*Proceedings of the Madras Government, Public Works Department,
12th December 1860.*

No. 179. Read the following letter from Lieutenant-Colonel W. H. HORSLEY, Chief Engineer, to J. D. SIM, Esq., Acting Secretary to Government, dated Chepauk, 30th November 1860, No. 7,515:—

1852.8/67.
Plan of a Bridge to be constructed
on the Salem and Trichinopoly Road near Namcul

Plan Elevation and Sections of a Bridge
 to be constructed over a jungle stream
 near Talapully on the Salem and Trichunopoly road

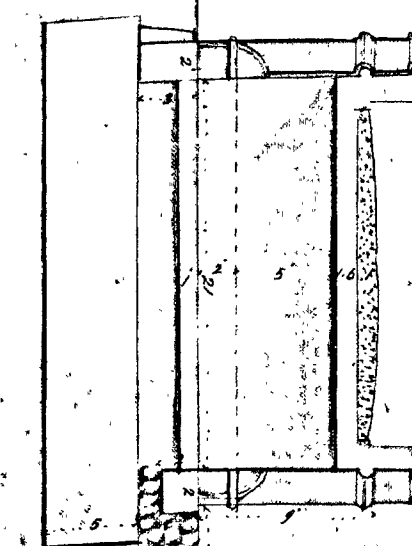
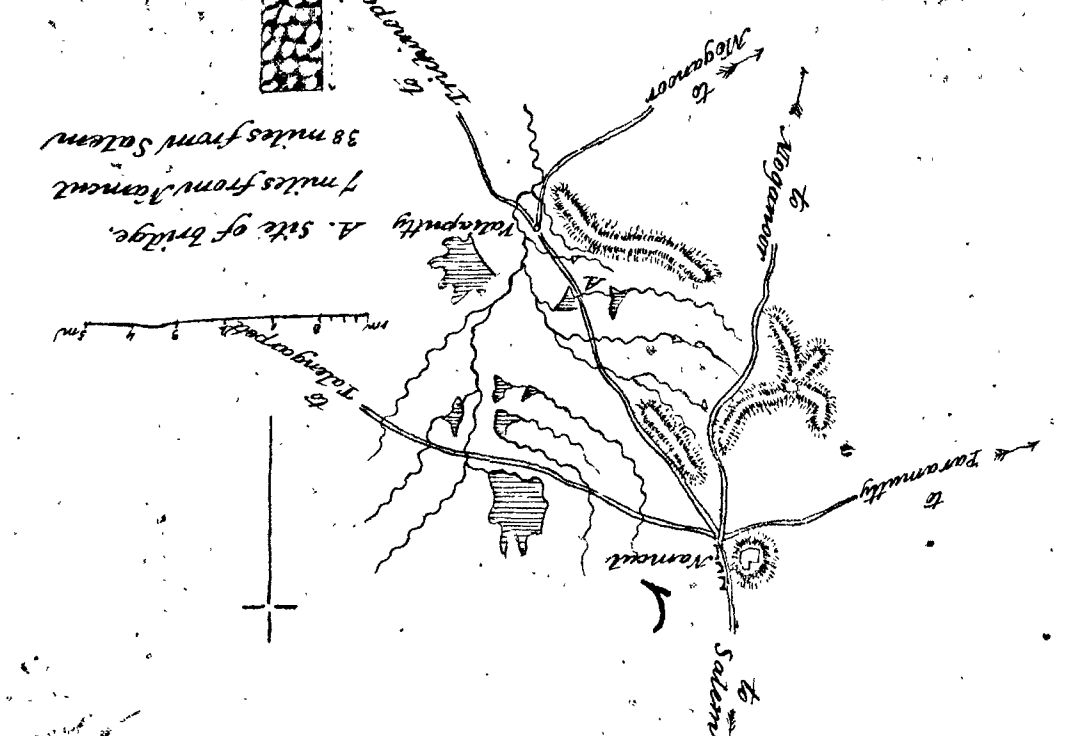
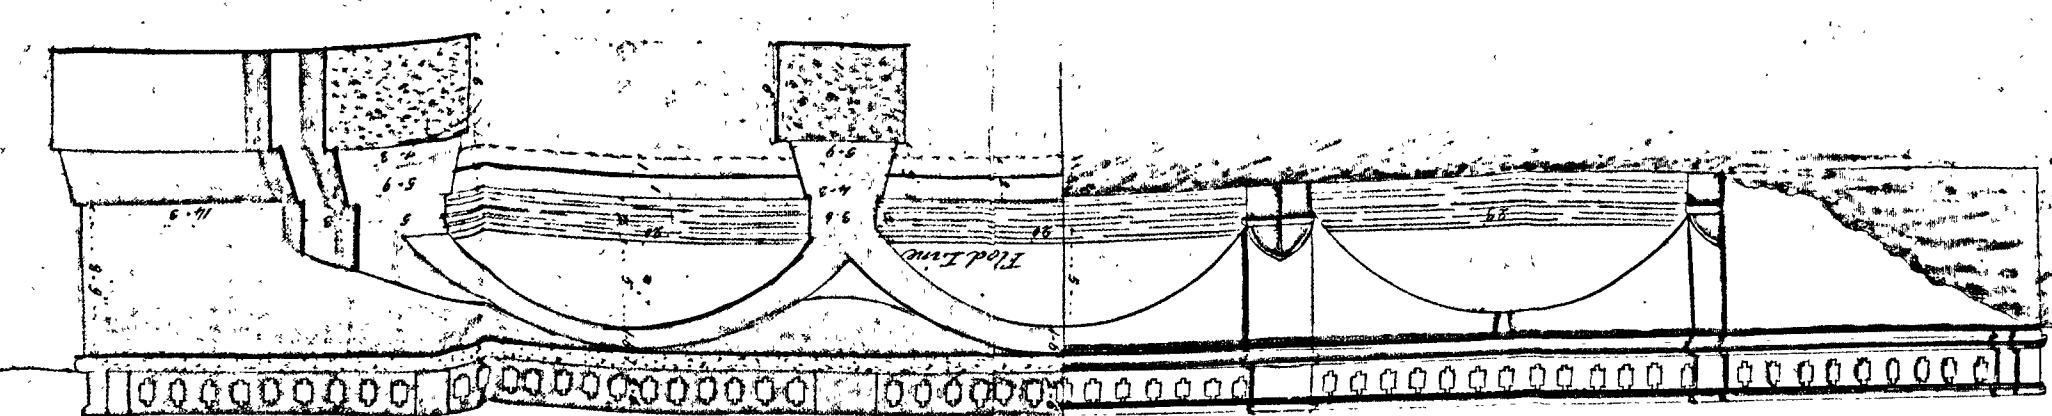
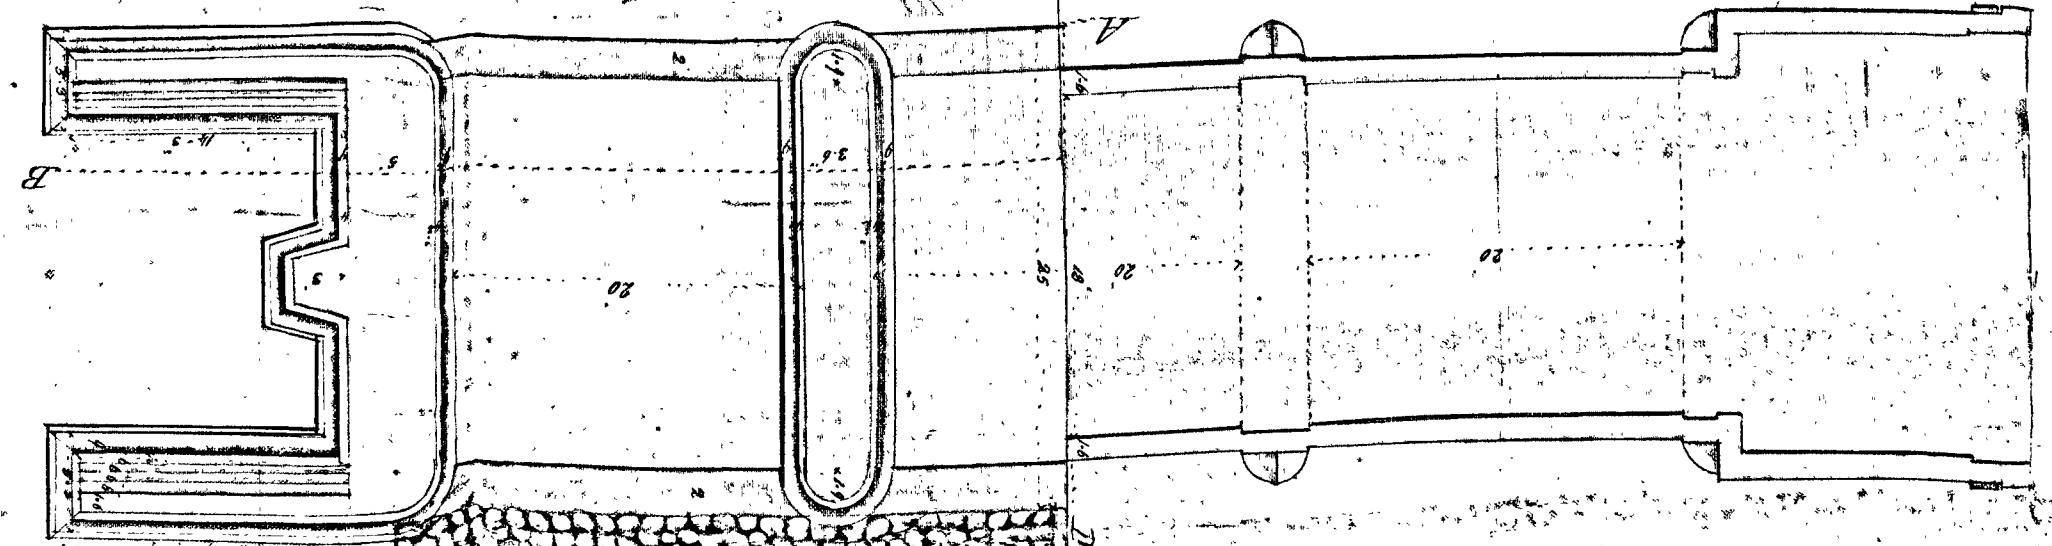
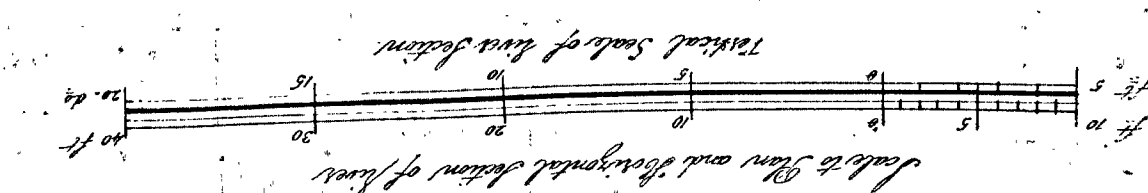
~~Water surface~~
A depth of 7' 6" is given to the foun-
dation in the plan, but the Specification
shows 8 feet.
The Retaining walls are marked 3 feet
deep in plan, but 4 feet in Specification.
The Apron is ~~marked~~ ^{stated as} 6 feet wide in
Specification, ^{but} the plan shows 10 feet.
The average height of wing walls shown
by 16 feet 6 inches, instead of 16 feet
as in the Specification.
The Specification does not mention

a portion of the retaining wall of rough stone in Chertam at ^{the foot} ~~new~~ end of the abutment.

Valiapatty Bridge

The rise of Arch is marked 7'-6" in
plan, & 7' ^{assumed} only in the Specification.

Abutments of 4' 6" ^{is needed} ~~not~~ for a bridge
of 30 feet span is insufficient.

Stream near Valiapatti on the
Salem and Trichinopoly road, you are
requested to explain why you
proposed 5 Arches of 12 feet span
each, in preference to 2 or 3 of
wider span. I have to point out
that the Plan is not in sufficient
detail for submission to Govt.

A Cross-section as well as a section
of the Wing walls should be given.

You will be good enough also
to state why you have placed the

Wing walls up-stream at nearly
right angles with the Bridge.

Especially as the banks of the
river seem so low, that in case

of a high fresh the water might
force its way round the end of
the Bridge.

It would be far
better to have 3 Arches
of 20 feet span & 5 feet
rise with piers and
abutments 3 feet above
foundations the piers
to be 3 feet thick & the
abutments 5 feet. The
present plan does
not provide sufficient
waterway

A fresh design is prepared in
this office & is herewith sent.

3. With regard to the other bridge, I have to state that my reason for proposing 5 Semicircular Arches of 12 feet Span is that I like the appearance of Semicircular Arches rising from the ground for such a shallow Stream as the one in question, and a greater height than that which I have given is not necessary.

I cannot but think that a District Engineer has a right to claim some discretion in trifling matters of this kind, or he will otherwise lapse into the position of a mere Draftsman. The waterway of this bridge is, you will find ample. I see more than double the sectional area of the highest floods.
